September 30, 1982
MN-83-190

Subject: I.E. Bulletin 80-11 - "Masonry Wall Design"

This letter transmits Maine Yankee Atomic Power Company's response to your request for additional information, Reference (b), regarding masonry walls at Maine Yankee. We have addressed each request and have provided additional information for your review.

Sample Drawing

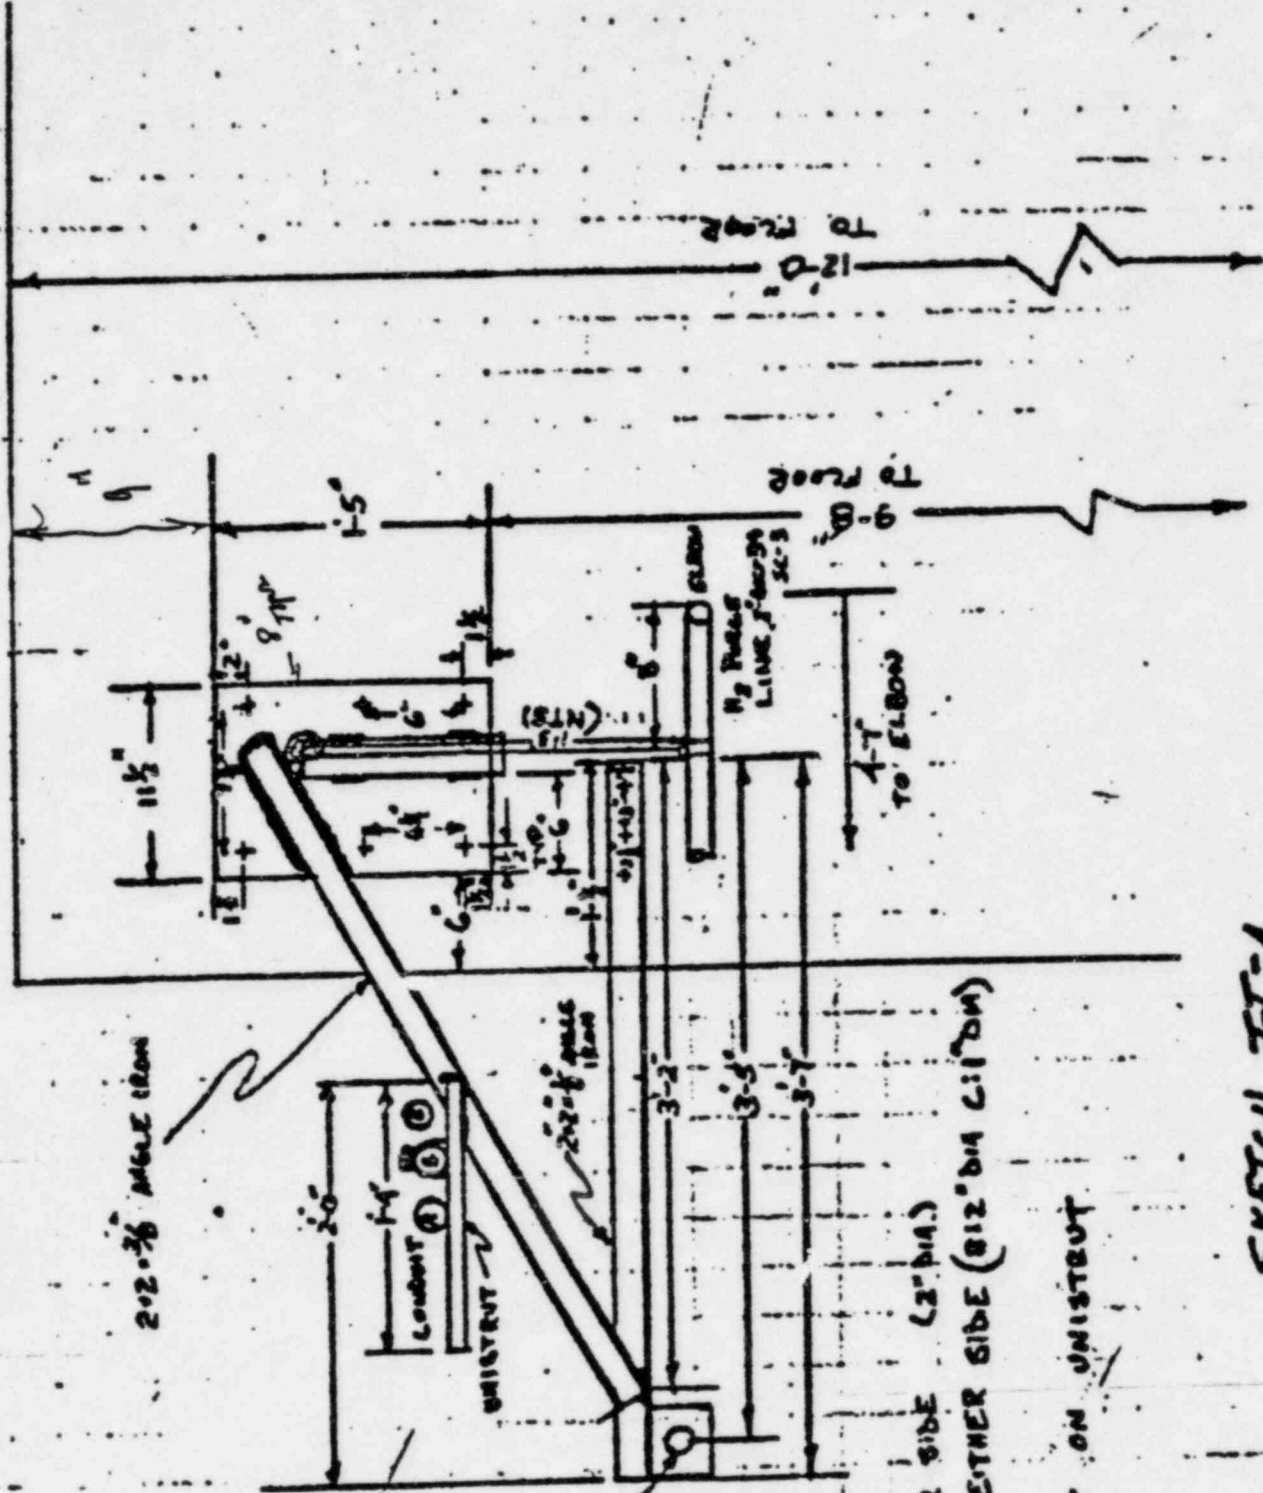
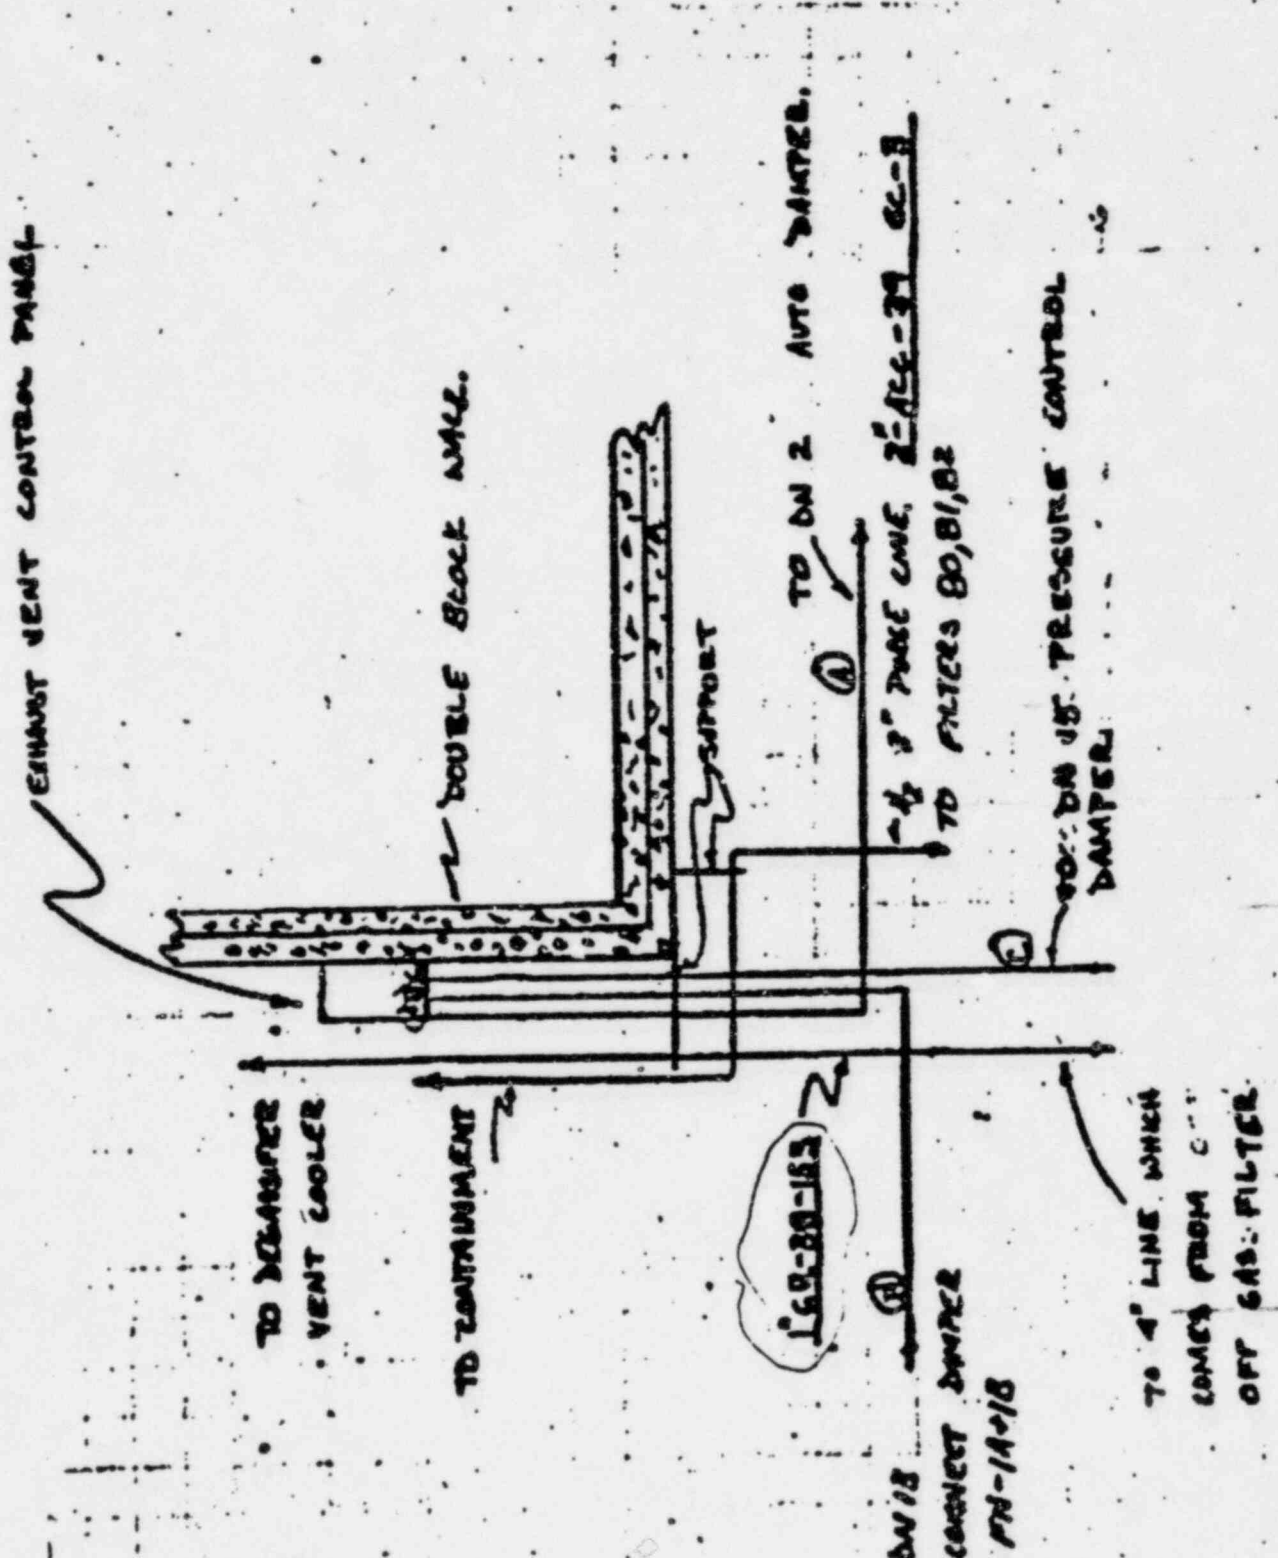
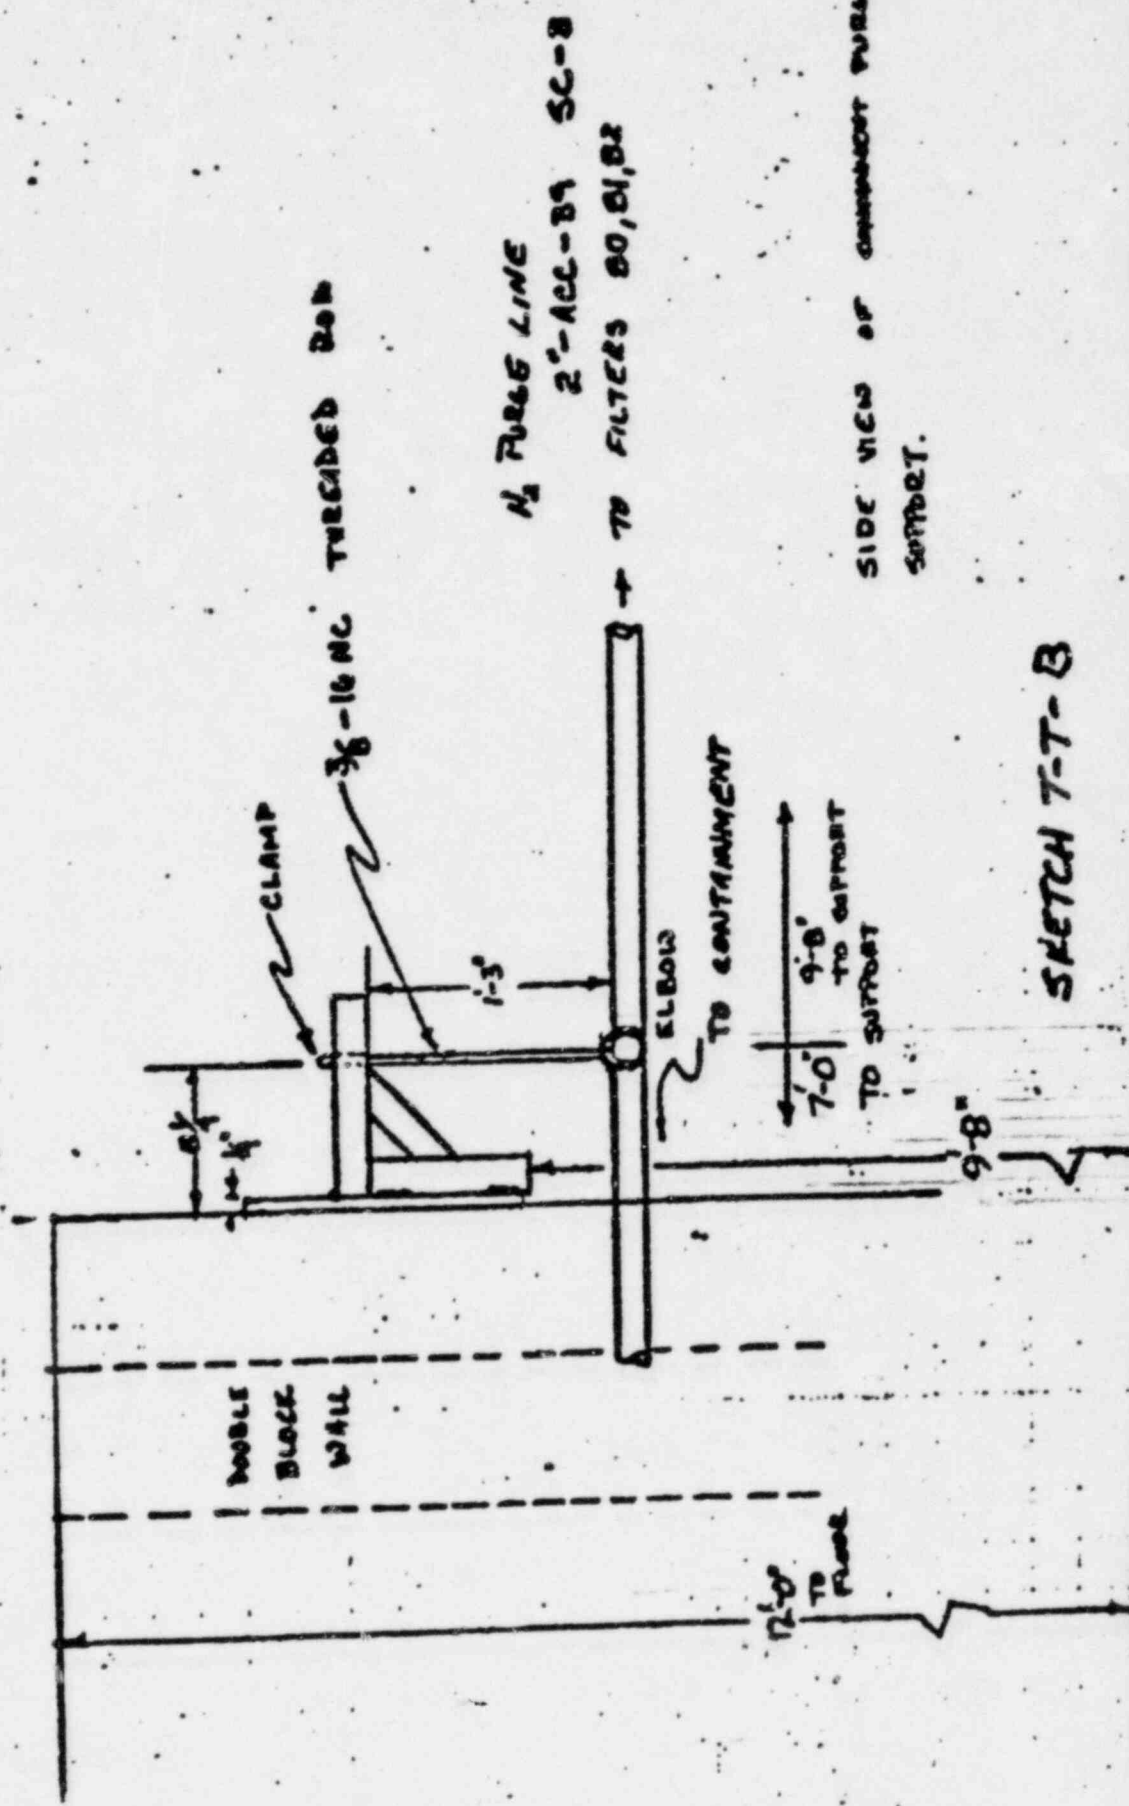
Provide sample calculations for block pullout analysis.

Refer to Enclosure B.

SK-A

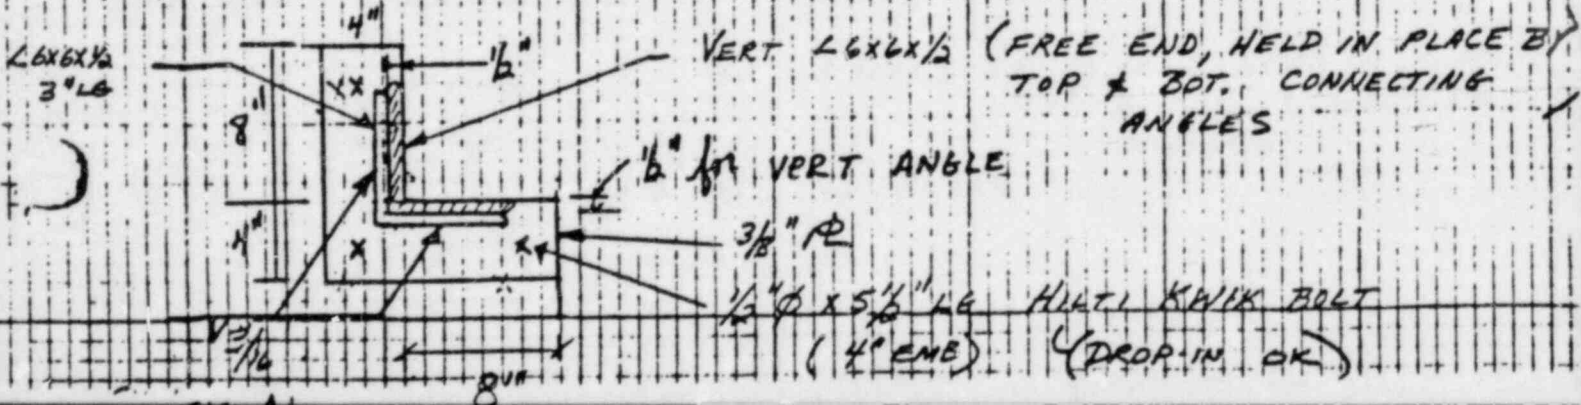
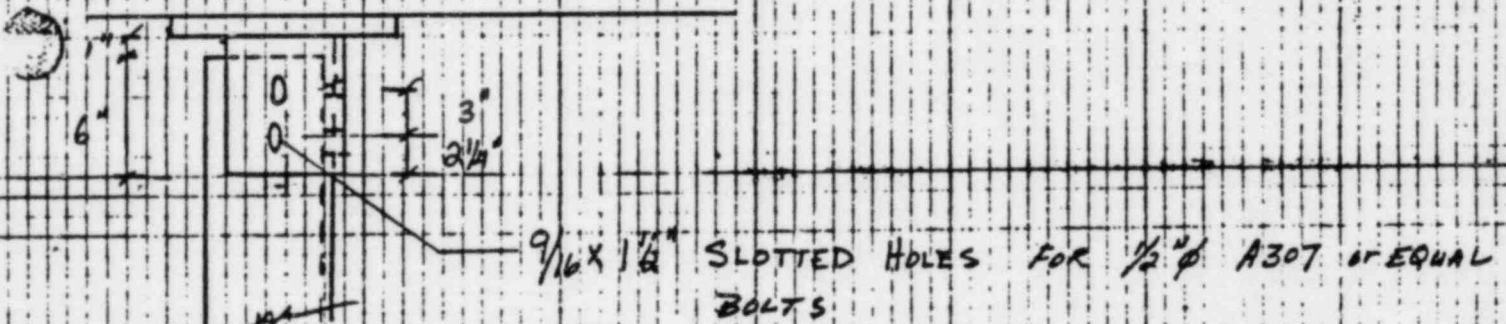
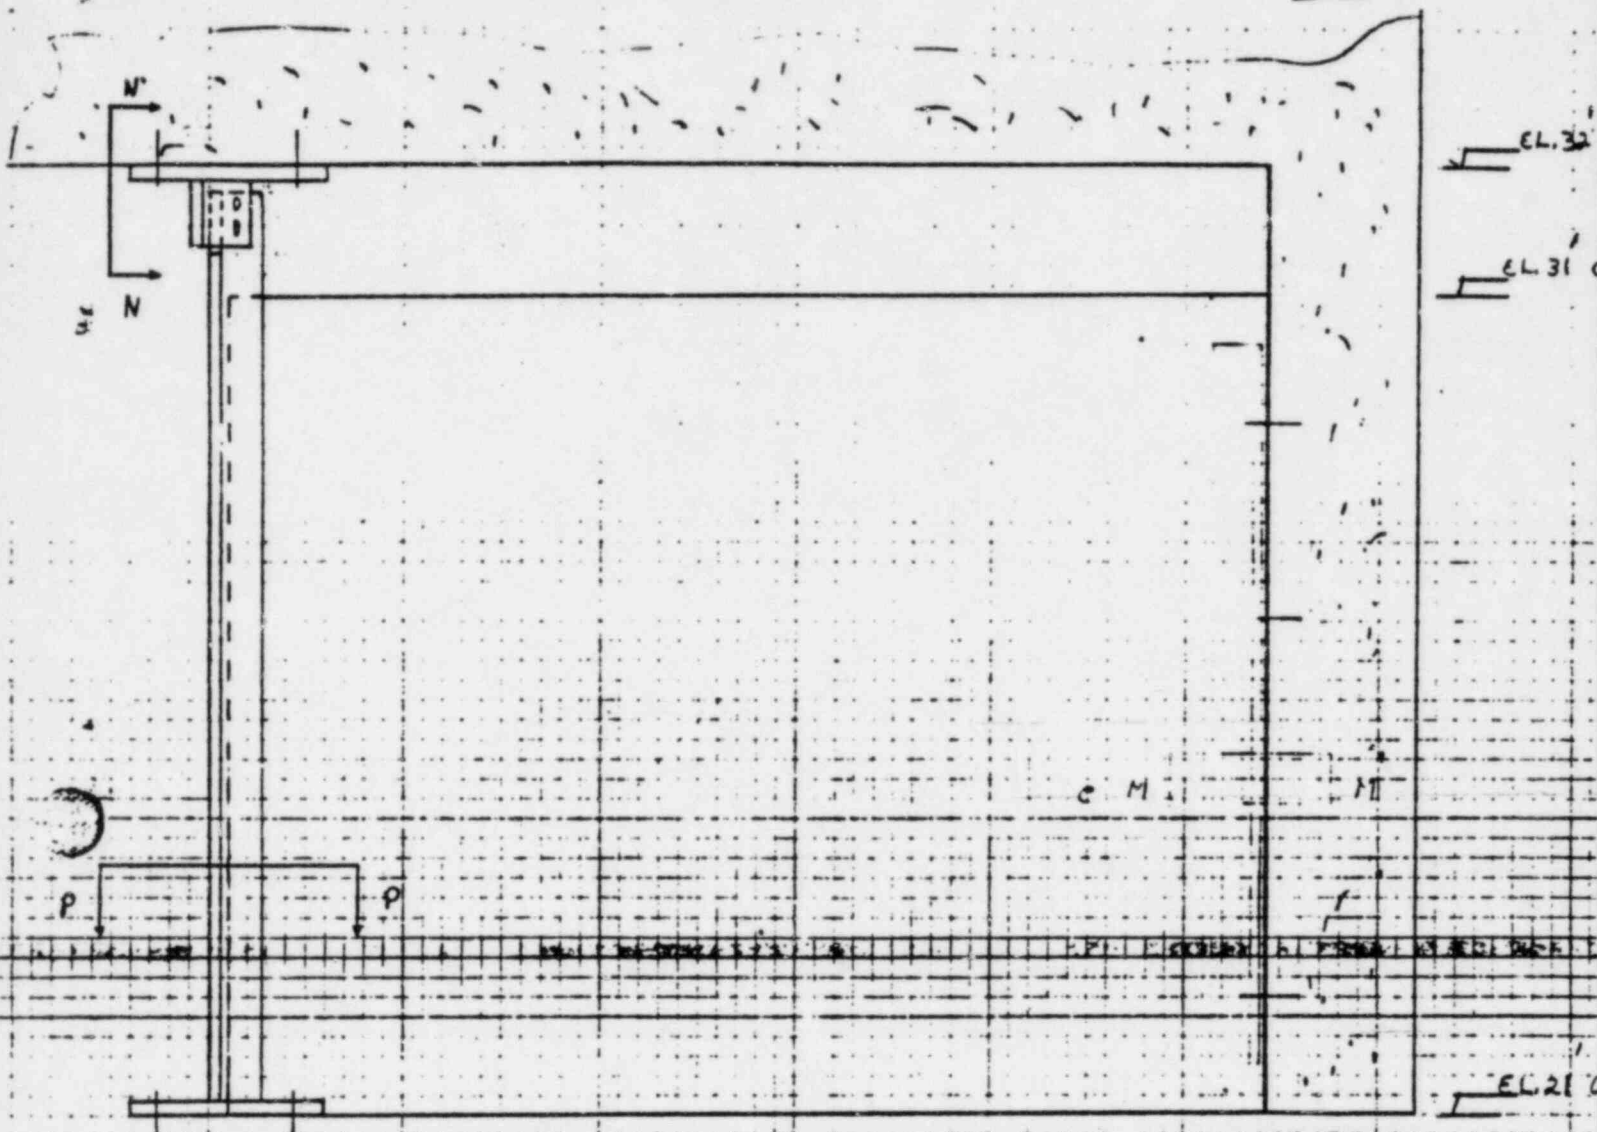
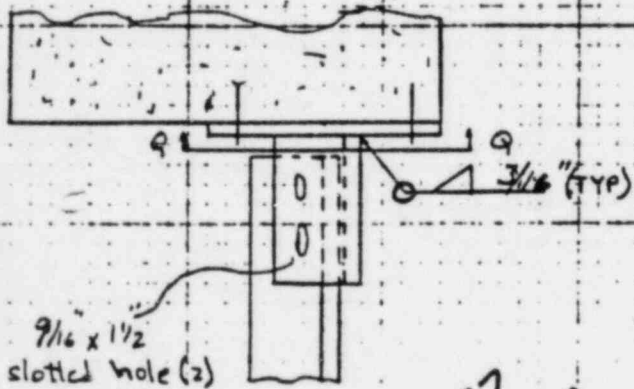
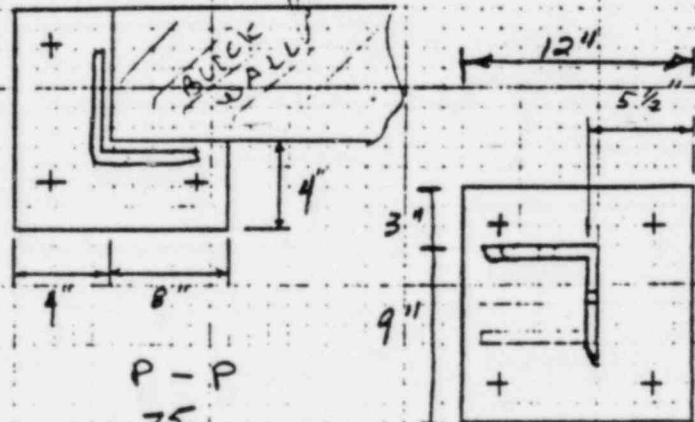
Provide the drawings of the deflection shield which was installed to prevent the stacked wall in the primary auxiliary building from falling into the surge drum area.

Refer to Enclosure C.

1) CONCLUSION: WALL APPEARS BORDERLINE FAR OUT OF PLANE LOADS AND CAPACITY OF DOOR FRAME TO ACT AS A SUPPORT IS QUESTIONABLE. DESIGN SOUTH END SUPPORT TO INSURE AGAINST P/P COLLAPSE IN S-E DIRECTION (TOWARD MCG)

THIS VALUE IS TOO LARGE FOR THE ANCHORS WE HAVE AVAILABLE \therefore A PINNED SUPPORT MUST BE DESIGNED
